PUBLIC COMMENT on PROPOSED BUILDING STANDARDS
For Publication in Title 24, California Code of Regulations

Rationale for Requesting Disapproval of Item 4 of Title 24, Part 2.5 Proposed by California State Fire Marshal

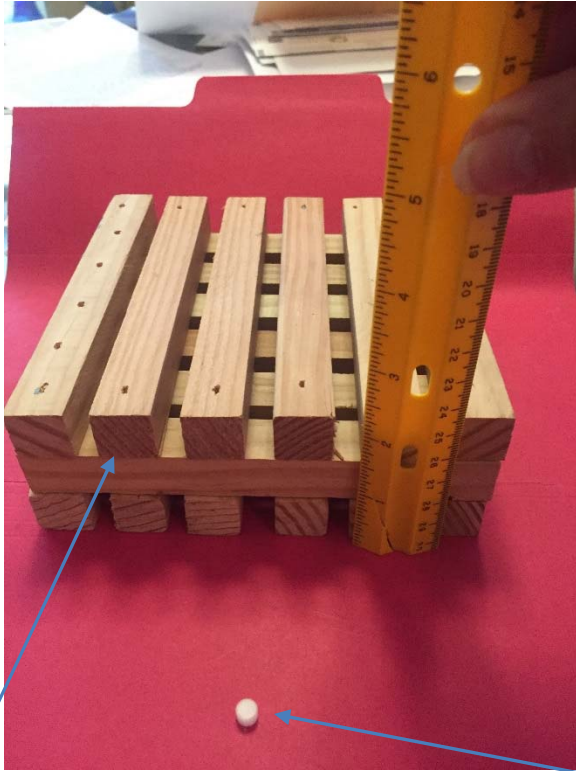
1. The OSU project demonstrated that fire retarded EPS (expanded polystyrene) foam was much less easily ignited than non-fire retarded expanded polystyrene (Non-FR EPS) foam.
2. The difference in ignition performance found by the OSU project was not minimal but very substantial. In detail, the ignition source in ASTM D2859 (which ignited the Non-FR EPS foam) is a methenamine pill that weighs 150 mg and has the approximate size of a shirt button (meaning that about 200 pills weigh an ounce) while the Class B ignition source from ASTM E108 (which was needed to ignite the FR EPS) is solid wood that weights 500 g (over a pound). There is no realistic comparison between the ease of ignition of the FR EPS foam and the Non-FR EPS foam. See photographs below.

Figure 9 FR EPS vs Non-FR EPS Methenamine Pill Test ASTM D2859

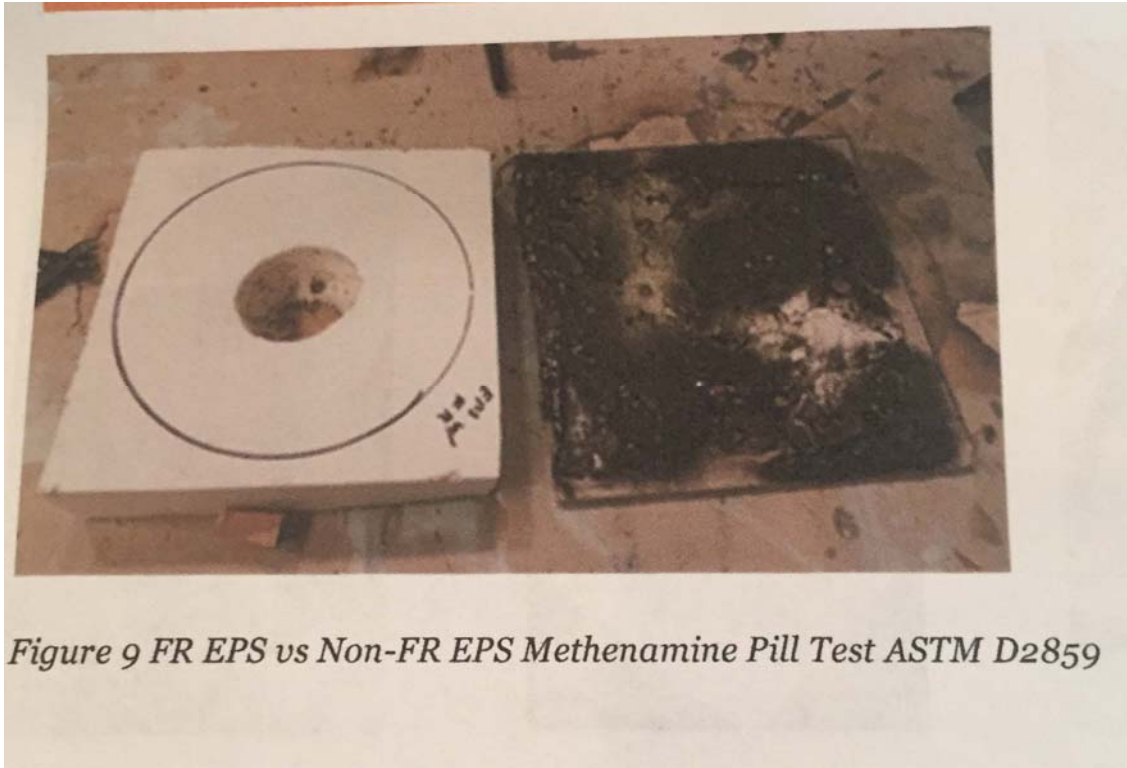
4. The photograph below shows, taken by OSU, the results of applying the methenamine pill to FR EPS foam (on the left) and Non-FR EPS foam (on the right): the difference is astounding.
